Concerned Products:	Customer Notification	Date: Sep. 21, 2000
<p><i>μPD703031A</i> <i>μPD703031AY</i> <i>μPD703032A</i> <i>μPD703032AY</i> <i>μPD703033A</i> <i>μPD703033AY</i> <i>μPD70F3032A</i> <i>μPD70F3032AY</i> <i>μPD70F3033A</i> <i>μPD70F3033AY</i> <i>μPD70F3033</i> <i>μPD70F3033Y</i></p>	Bug Report	<p>NEC-Electronics (Europe) GmbH EAD –Technical Product Support</p> <p>Source Doc: HW 260199 HW 080299 SBG-T-1719 SBG-T-1777 SBG-T-2107</p> <p>Author: H.-W. Hoefl, Udo Wenzel</p>
Date of initial issue: Feb 19 th 99		Doc. No.: TPS-HE-B-2122

(A) BUG LIST

3 TM 2-5 operational defect

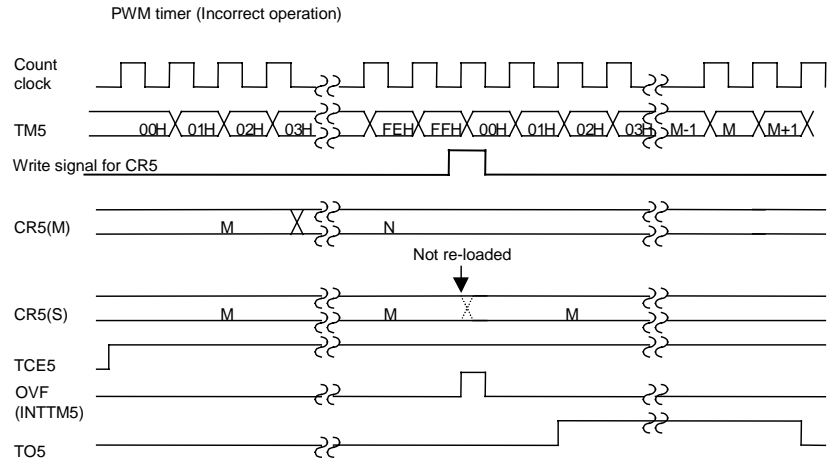
- If the CR20-50 register is read when an overflow occurs, the CR20-50 master register will not transfer data to the CR20-50 slave register. The data is transferred when the next overflow occurs.

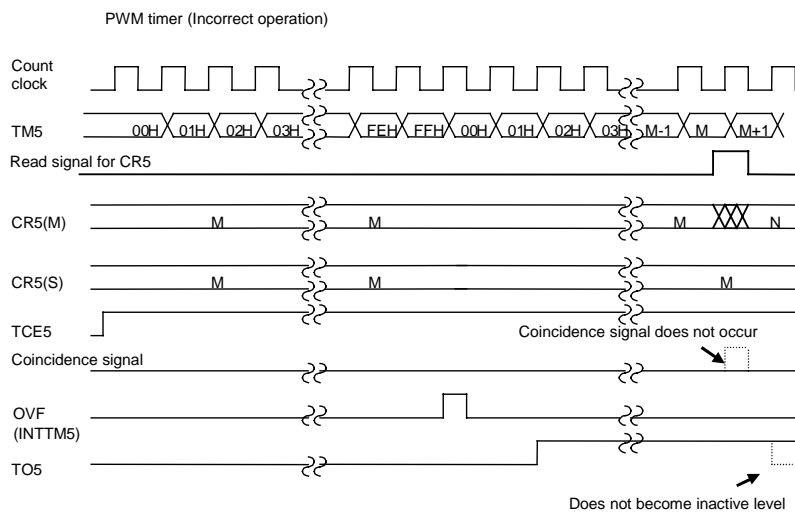
- If the compare register (CR20-50) is written when the timer register (TM2-5) and compare register (CR20-50 [slave register]) coincide, a coincidence signal is not generated and the inactive level is not attained.

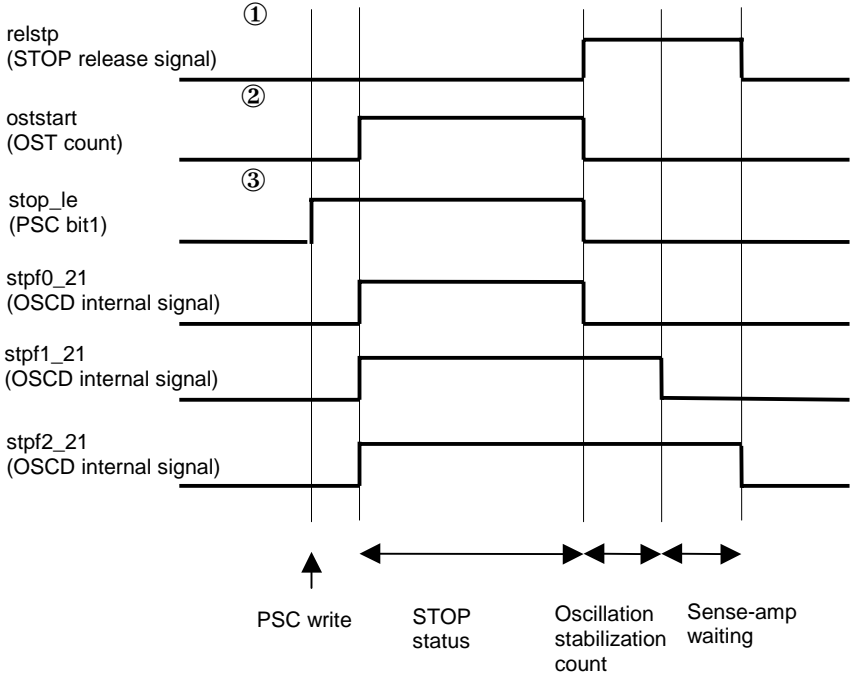
Bug No.	Outline	Description
4	Using the IIC restart condition causes a faulty address transfer.	<p><u>Details</u> If the transfer address is set to the shift register (IIC0) immediately after the (re)start is set (STT = 1), the transfer address will be sent simultaneously by rising edge of the serial clock (SCL). The serial clock is at low level normally before a restart condition will be set, due to the preceded address/data transfer. To generate a (re)start condition the serial clock (SCL) has to be first on high level (recessive state). By falling edge of the SDA line, when SCL has high level, the (re)start condition can be detected. Afterwards the SCL line will fall to low level and the slave address can be transferred by normal operation. Now, if the slave address is written into the shift register (IIC0) immediately after the start condition trigger (STT0) is set, the rising edge on the SCL line resulting in data output before the start condition is set. This causes the bug.</p> <p><u>Workaround</u> The transfer address must be set after the confirmation of start condition detection (STT=0, STD = 1).</p>  <pre> graph TD Start([Start]) --> Set[Set (re)start condition STT0 = 1] Set --> STT0{STT0 = 0} STT0 -- NO --> Wait1[wait until the start condition has been accepted] Wait1 --> STT0 STT0 -- YES --> STD0{STD0 = 1} STD0 -- NO --> Wait2[wait until the start condition has been detected] Wait2 --> STD0 STD0 -- YES --> Write[Write transfer address to IIC0 register.] Write --> End([End]) </pre>

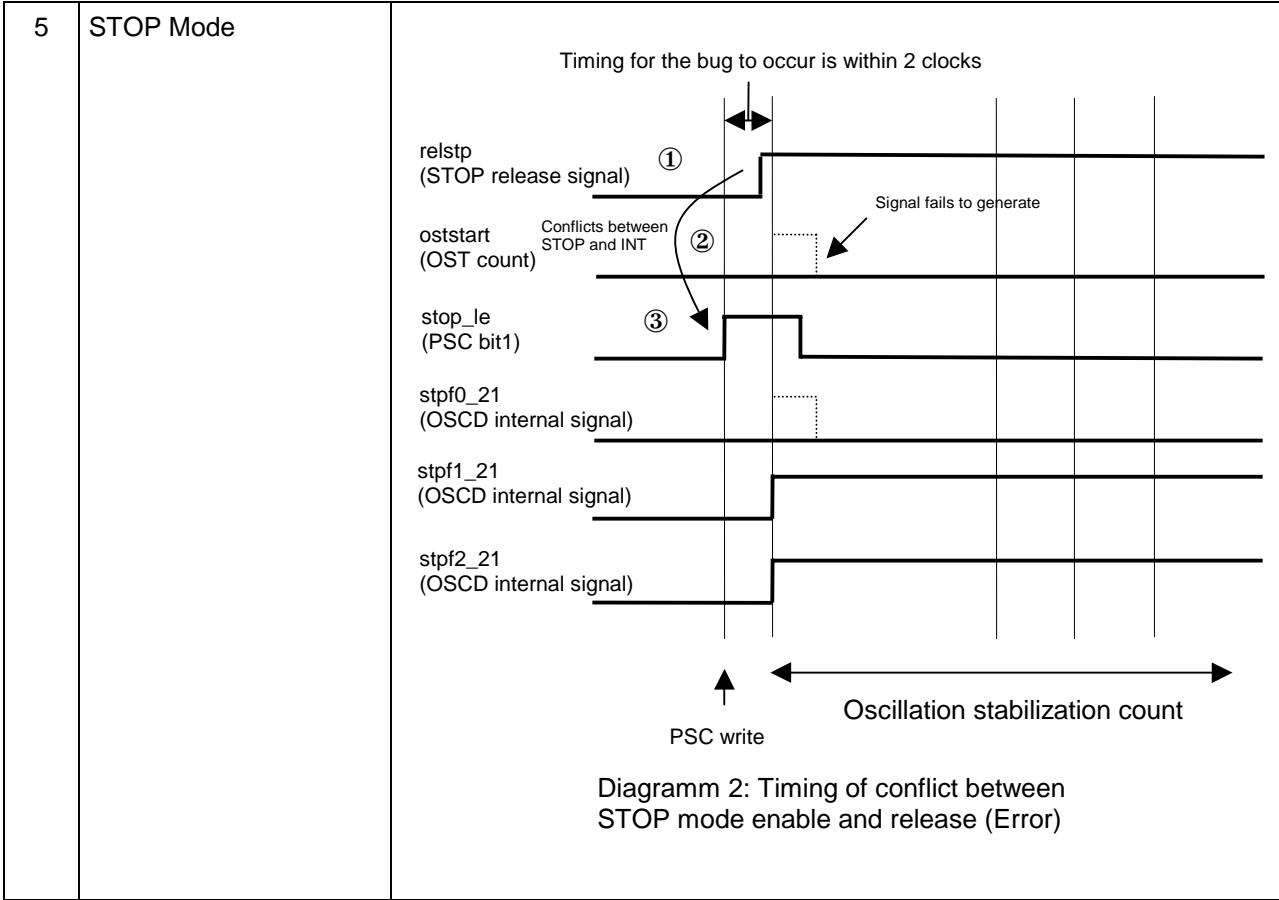
Bug No.	Outline	Description
5	STOP Mode	<p>The CPU becomes deadlocked, if the timing of a STOP mode enable and a Stop mode release are in conflict</p> <p><u>Details</u></p> <p>With the V850/SA1, the STOP mode is enable by writing (stop_le^③) to the PSC register (Power Save Control register). To release the Stop mode, the count initialization signal (oststart:^②) is generated to start the WDT (watchdog timer) that counts out the oscillation stabilization time (refer to diagram 1). However, if the stop mode release signal (relstp:^①) because of an interrupt, etc. conflicts with writing to the PSC register (the timing for the bug to occur is within 2 clocks), then the oststart signal is not generated and WDT does not start counting. This means that the microcomputer remains waiting for the oscillation stabilization time to elapse, and even if the stop mode release signal is generated, STOP mode cannot be released (refer to diagram 2).</p> <p><u>Workaround</u></p> <p>As a temporary measure it is suggest that you use the IDLE mode or sub-IDLE mode instead of the STOP mode.</p>  <p>Diagramm1: STOP release operation timing (Normal)</p>

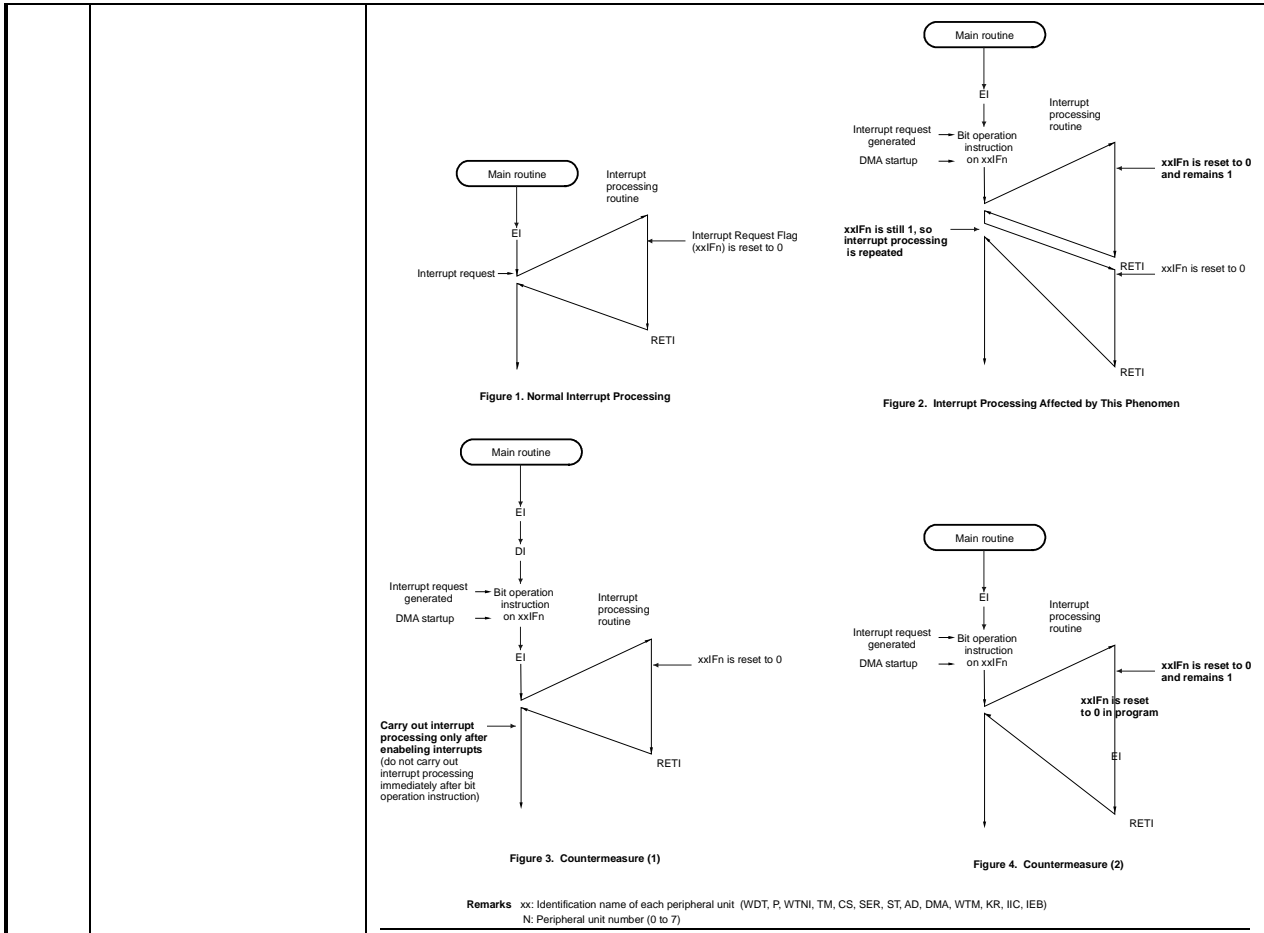
Bug No.	Outline	Description
9	Double interrupt execution	<p><u>Details</u></p> <p>An interrupt that should occur only once occurs twice if the following three conditions occur simultaneously while interrupts are enabled:</p> <ol style="list-style-type: none"> 1) A bit manipulation instruction (set1, clr1, not1 or tst1) is executed on an interrupt request flag (xxIFn) of an interrupt control register (xxICn). 2) Interrupt processing involving the hardware of the same register occurs 3) There is a DMA startup while executing the above bit operation <p>Remark: xx: Identification name of a peripheral unit (WDT, P, WTNI, TM, CSI, SER, ST, AD, DMA, WTN, KR, IIC) n: peripheral unit number</p> <p>If the abovementioned condition appears, the Interrupt Request Flag, which is normally reset to 0 at the acknowledge of interrupt processing, will not be reset. Consequently, after returning from interrupt processing (reti instruction), the interrupt processing is executed again. This does not happen if DMA is not used.</p> <p><u>Example:</u></p> <p>During a bit manipulation operation using the clr1 instruction on the interrupt request flag of the CSIC0 register (CSIF0), the non-masked INTCSI0 interrupt occurs at the same time as a DMA startup. As a result the INTCSI0 interrupt processing is executed twice.</p> <p><u>Workaround:</u></p> <ol style="list-style-type: none"> 1) Insert a DI instruction before and an EI instruction after executing a bit manipulation instruction on an interrupt request flag (xxIFn) of an interrupt control register (xxICn) to avoid carrying out interrupt processing immediately after executing the bit manipulation instruction. 2) When interrupt processing begins, the hardware enters a state where interrupts are disabled. Clear the interrupt request flag in all interrupt processing routines before executing the EI instruction.
